**BIG HORN COAL COMPANY
10980 SOUTH JORDAN GATEWAY
SOUTH JORDAN, UT 84095**

April 23, 2020

RE: Objections to Proposed Brook Mine Permit Application, Sheridan County, Wyoming

Attachment: BHCC Objection No.4 Attachment 1

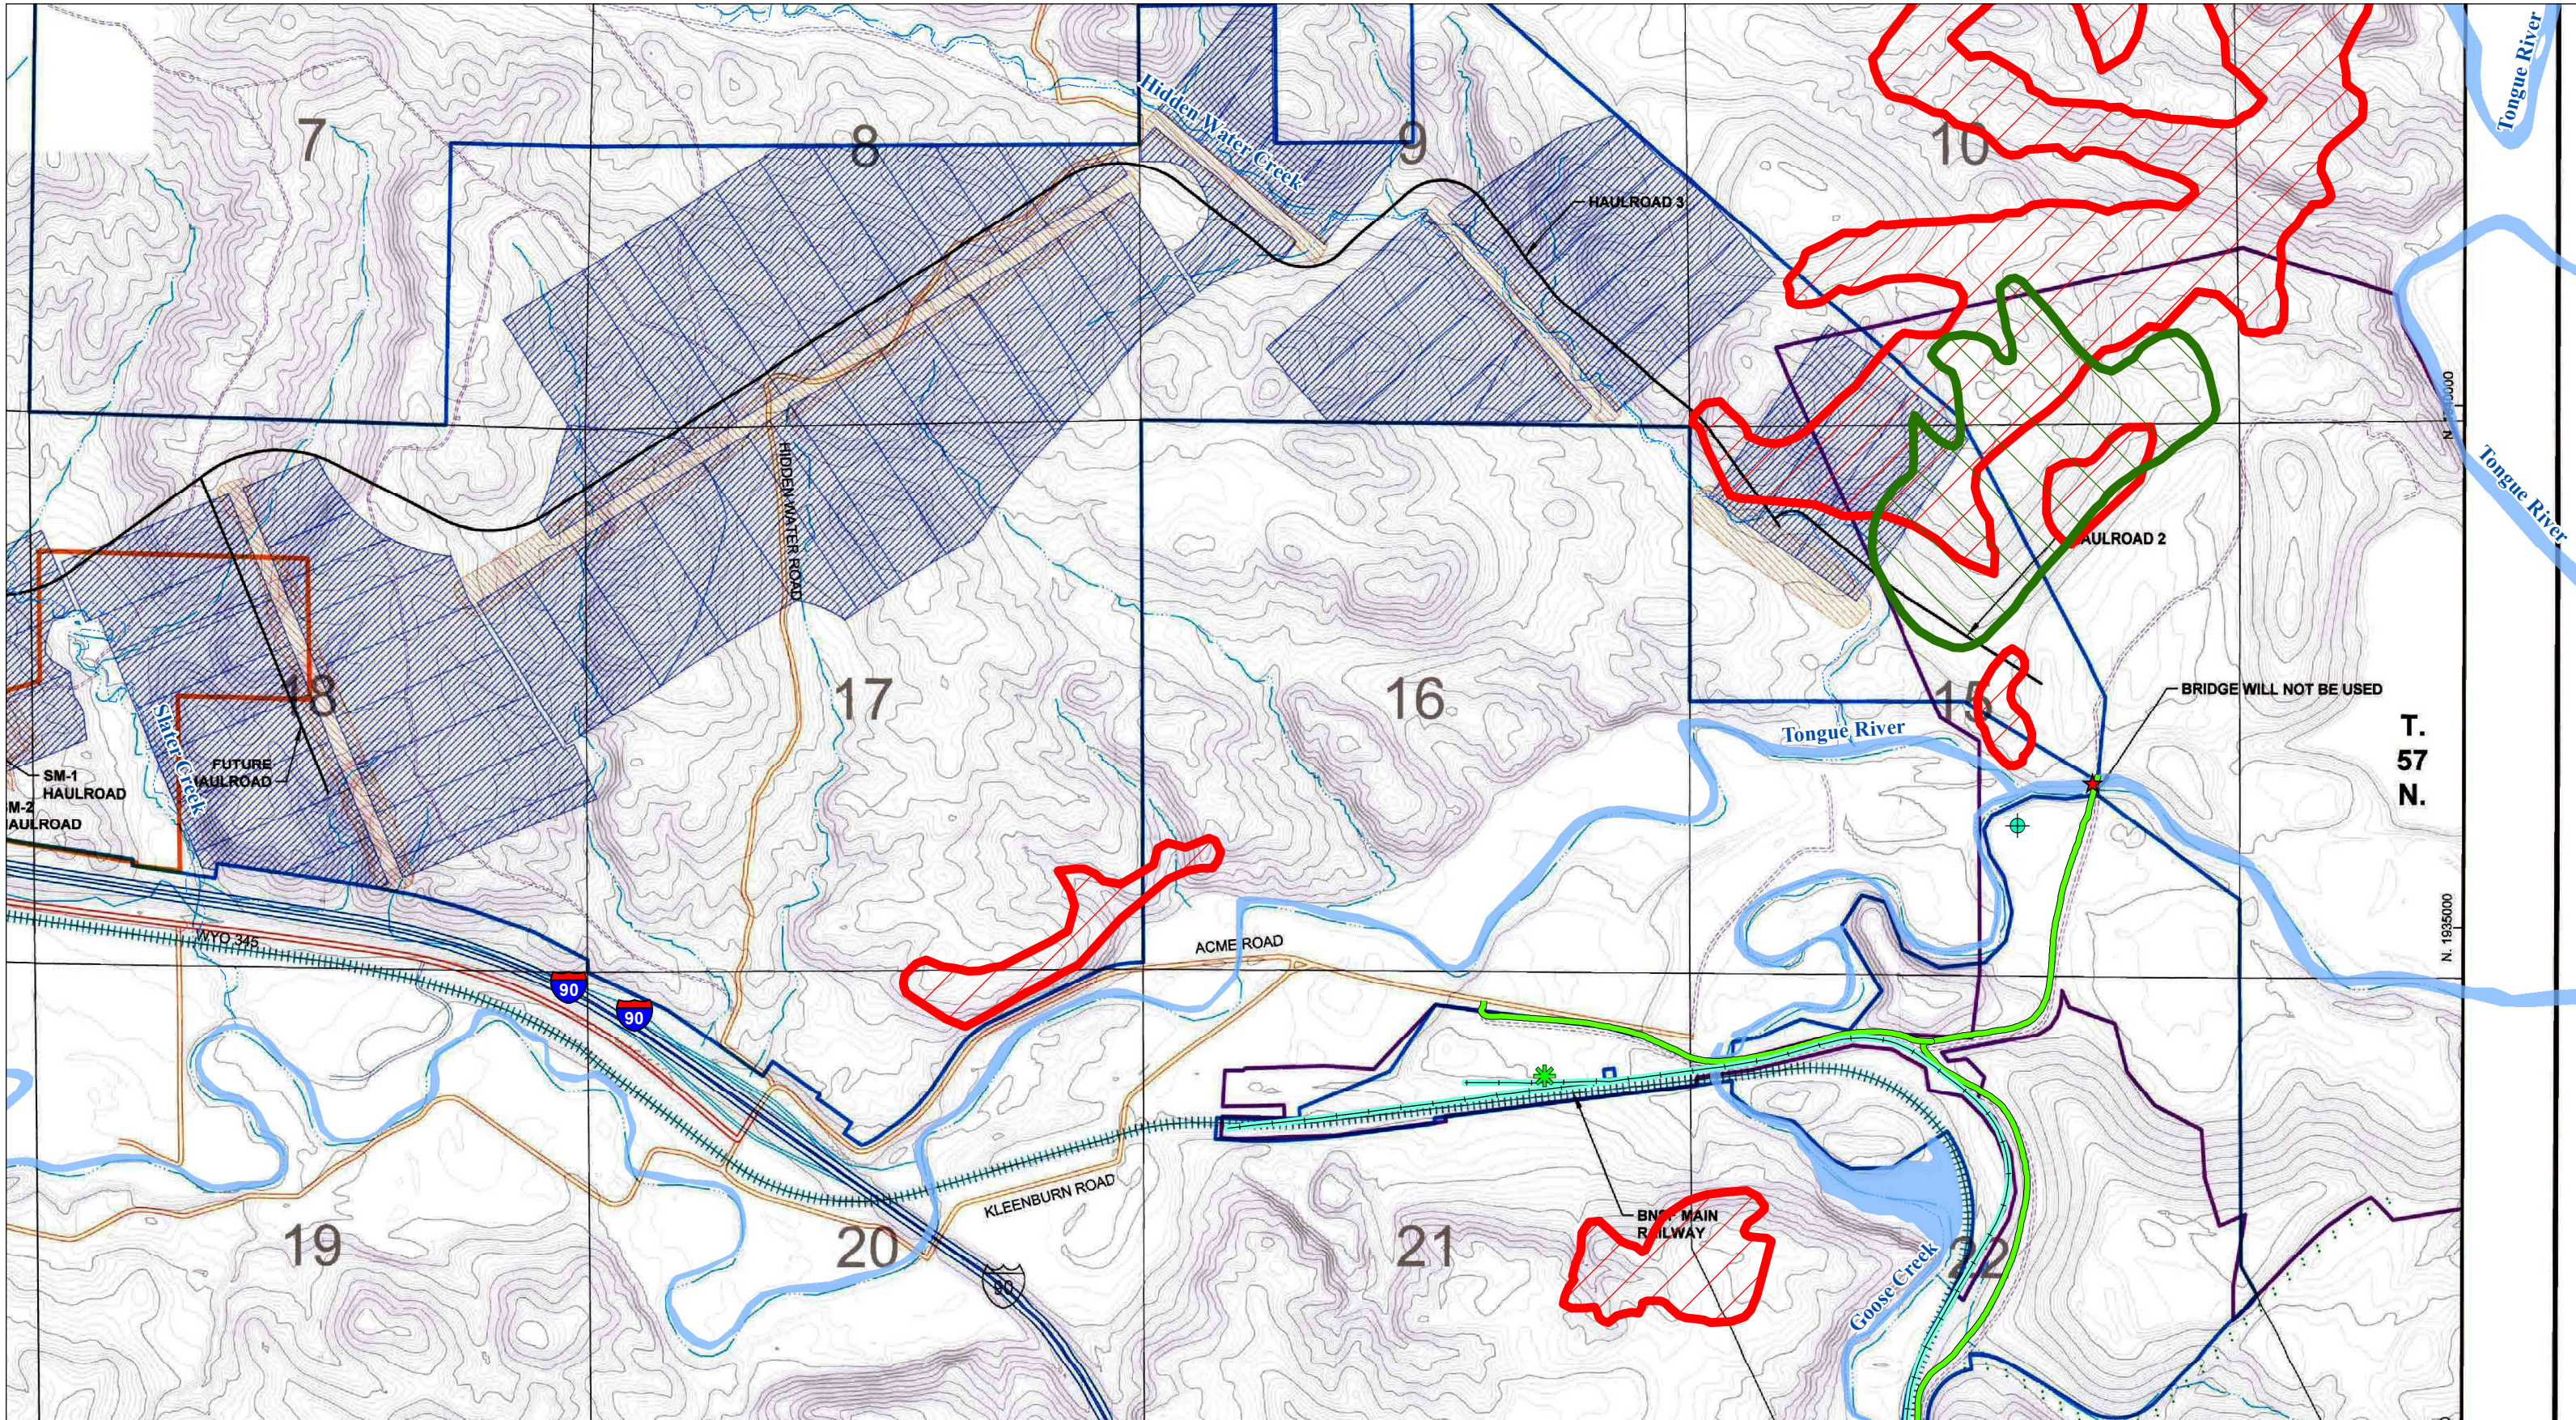
The fire control plan referenced in Section MP.11 and presented in Addendum MP-5 describes measures to be taken to prevent and control fires in the mine pits, fires in the mine's processing and shop facilities, equipment fires and rangeland fires. BHCC objects, however to the proposed Mine Plan and Addendum MP-5 not providing plans to control and extinguish new subsurface coal fires that may develop or existing subsurface coal fires that may become rekindled or enlarged as a result of the highwall mining panels that will be opened outboard of the highwall trench openings.

Attachment 1 provided with this Objection No. 4 is a drawing showing the approximate extent of underground coal mine fires in the area of proposed highwall mining in Sections 10 and 15, T57N, R84W, as reported by the U.S. Geological Survey in 1980. The fires in this particular area originated with mining of the Monarch coal seam. This and other nearby historic underground mines have long been known to exhibit numerous subsidence features and underground coal mine fires, and in the late 1980s BHCC received approval from the WDEQ/LQD to permanently place nearly 10 million bank cubic yards of overburden over the area shown on Attachment 1 in an attempt to reclaim the subsidence and control the fire. That unique reclamation feature is known as the Pit 3 Subsidence Dump in Big Horn Mine's reclamation history. The proposed highwall mining will develop mine openings in the Carney and Masters coal seams beneath the Monarch seam in areas that are known to still exhibit evidence of underground coal fires. Plumes of steam and smoke have been observed again over the general area of Sections 10 and 15 this winter of 2016-2017. These observations indicate that, in certain places, the perimeter of the historic subsurface coal seam fires has expanded notable distances from the referenced 1980 boundary delineation.

Objection No. 4 above introduces the fact that the underground mine fires in this area are still burning and have expanded. Section MP.15 does not, in any way, address that the burned areas have expanded. A surface mine excavation that comes in contact with a historic mine fire could be catastrophic in many ways, including: impacting the safety of mine workers, damage to equipment, wildfire initiation, etc. BHCC believes this proposed Mine Plan has not adequately addressed surface mining activities that will occur near underground mines and insists that the Brook Mine operators must perform the necessary testing and analyses to prove that the proposed Mine Plan will not be impacted by historic mine fires. Specifically, attachment 1 provided with Objection No. 3 above shows that trench TR-1 is planned very near an area that was burning and is likely still burning. Given that the burned area has likely expanded, this area should not be disturbed at all.
